SUBJECT: ISSUANCE OF AMENDMENT CYCLE 2 CORE RELOAD CHANGES (TAC NO. M98258)

The Commission has issued the enclosed Amendment No. 7 to Facility Operating License No. NPF-90 for Watts Bar Nuclear Plant, Unit 1. This amendment is in response to your application dated March 27, as supplemented May 28 and June 4, 1997.

Amendment No. 7
License No. NPF-90

SAFETY EVALUATION BY THE OFFICE OF NUCLEAR REACTOR REGULATION
RELATED TO AMENDMENT NO. 7 TO FACILITY OPERATING LICENSE NO. NPF-90
TENNESSEE VALLEY AUTHORITY
WATTS BAR NUCLEAR PLANT, UNIT 1
DOCKET NO. 50-390

Figure 2.1.1-1 (page 1 of 1)
Reactor Core Safety Limits

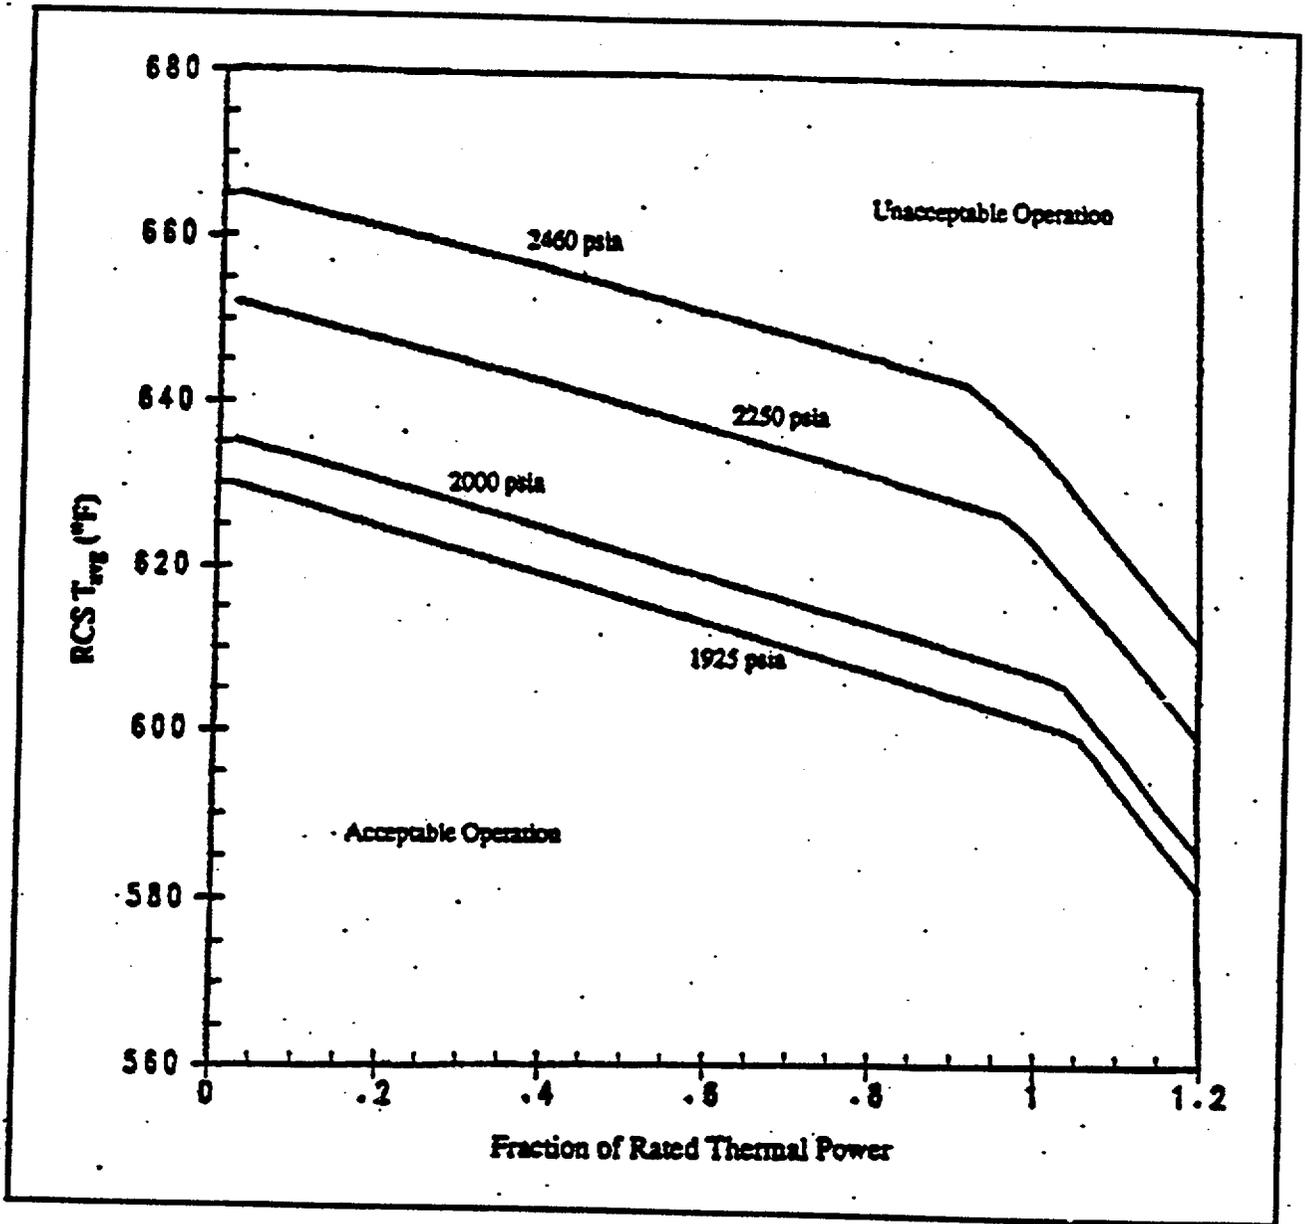
2.1 TS Figure 2.1.1-1, "Reactor Core Safety Limits"

Core safety limits, shown as the combination of thermal power, reactor coolant system (RCS) highest loop average temperature, and pressurizer pressure, in Figure 2.1.1-1, have been revised to account for the use of the Revised Thermal Design Procedure (RTDP) methodology for Cycle 2. The RTDP methodology, which has been previously approved by the staff, statistically combines uncertainties in plant operating parameters, nuclear and thermal parameters, fuel fabrication parameters, computer codes, and DNB correlation predictions to obtain DNB design limits. Use of the RTDP methodology requires that variances in the plant operating parameters (pressurizer pressure, primary coolant temperature, reactor power, and reactor coolant system flow) be justified. Therefore, in support of the use of the RTDP, TVA submitted WCAP-14738, "Westinghouse Revised Thermal Design Procedure Instrument Uncertainty Methodology for Tennessee Valley Authority Watts Bar Unit 1," which addressed the changes to the instrument uncertainties for the primary system operating parameters. These uncertainty values are acceptable and they, or more conservative values, have been used in the RTDP analysis. Since the uncertainties in the initial operating conditions (i.e., pressure, temperature, power and flow) are accounted for in the calculation of the core design evaluation of the DNB safety analysis limit, they are not explicitly included in the transient analysis of DNB-related events which use the RTDP methodology. However, these uncertainties are appropriately applied to the initial operating conditions in other applicable transients which are not analyzed to investigate the minimum DNB response.

below, were based on the revised reactor core safety limits in TS Figure 2.1.1-1 discussed previously and are acceptable in that they provide adequate assurance that the safety limits will be met.
